TRAILS AT ASPEN RIDGE FILING NO. 4

EL PASO COUNTY, CO

ROADWAY & STORM IMPROVEMENT PLANS

AUGUST 2021

DATE ISSUED: AUGUST 2021
SHEET 22 OF 50

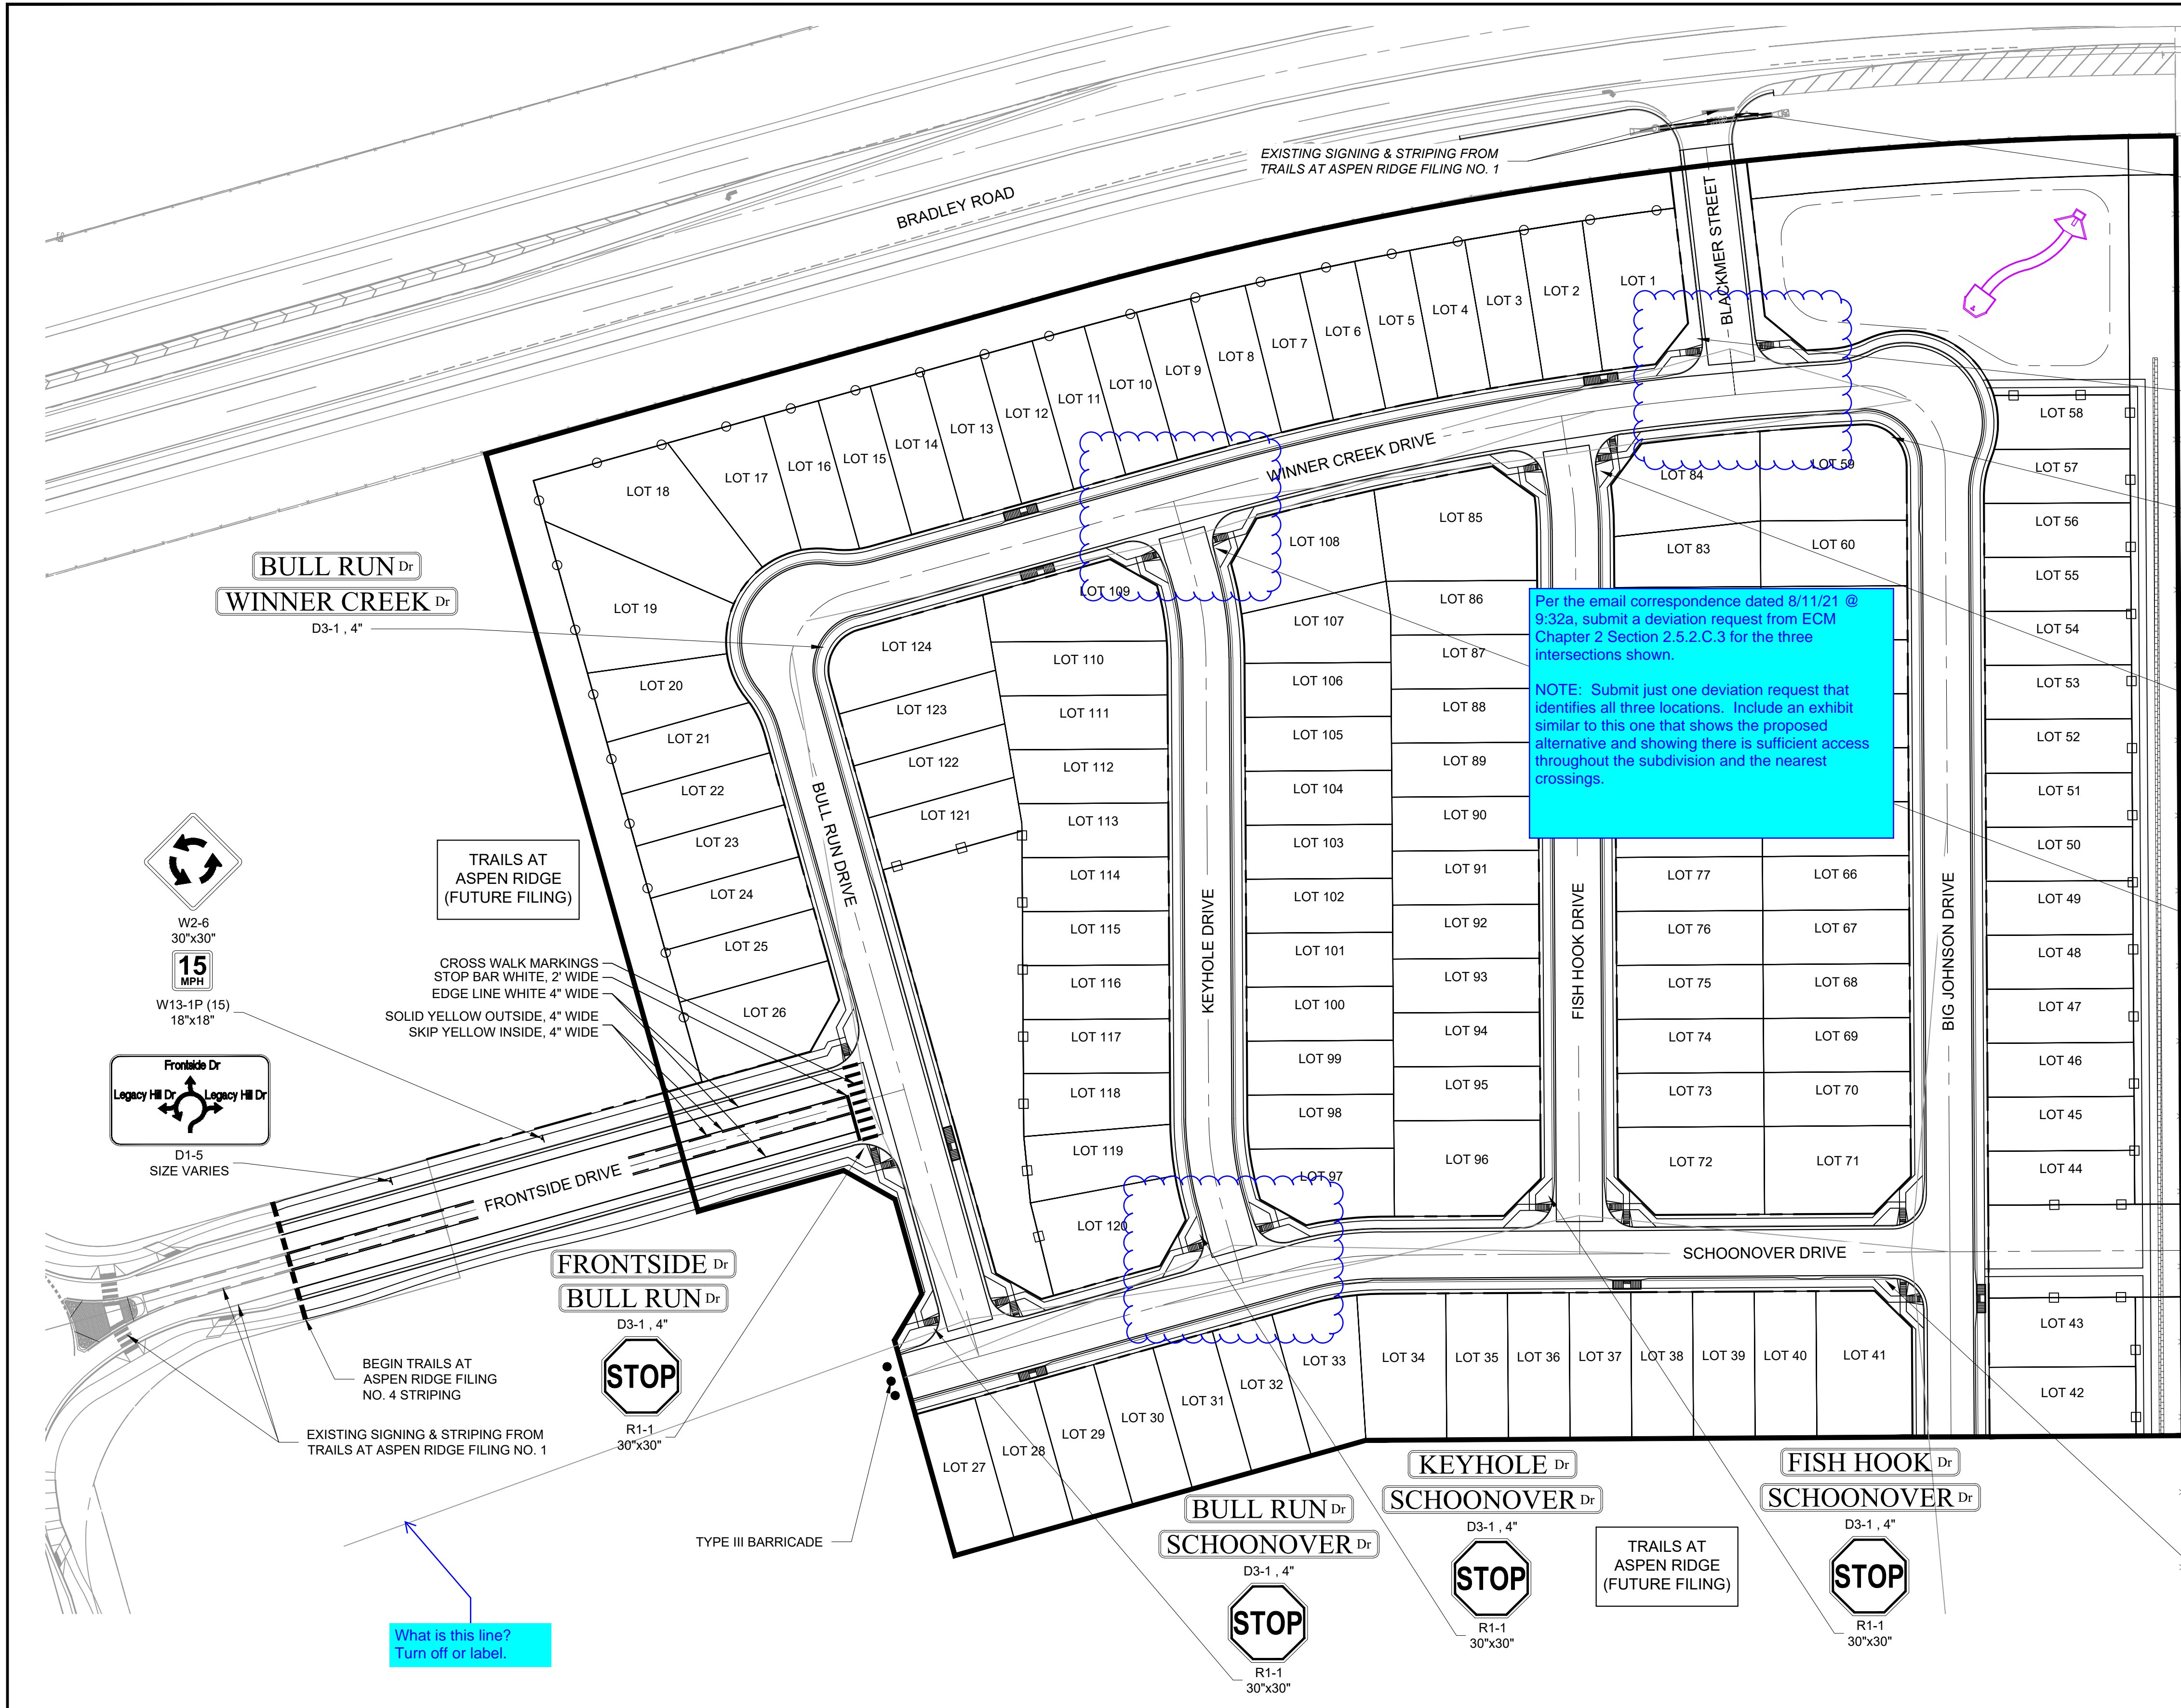
Per the email correspondence dated 8/11/21 @ 9:32a, submit a deviation request from ECM Chapter 2 Section 2.5.2.C.3 for the three intersections shown.

NOTE: Submit just one deviation request that identifies all three locations. Include an exhibit similar to this one that shows the proposed alternative and showing there is sufficient access throughout the subdivision and the nearest crossings.

DRAWING No. SN01

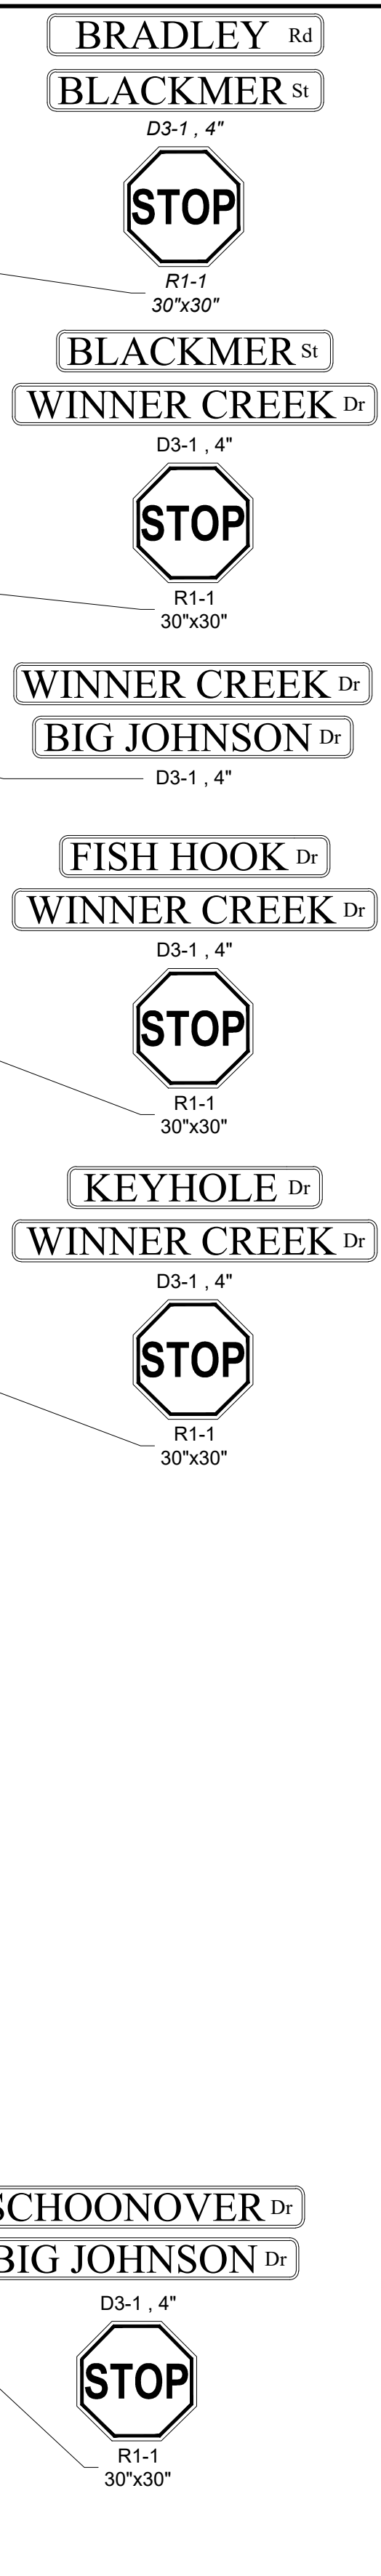
What is this line?
Turn off or label.
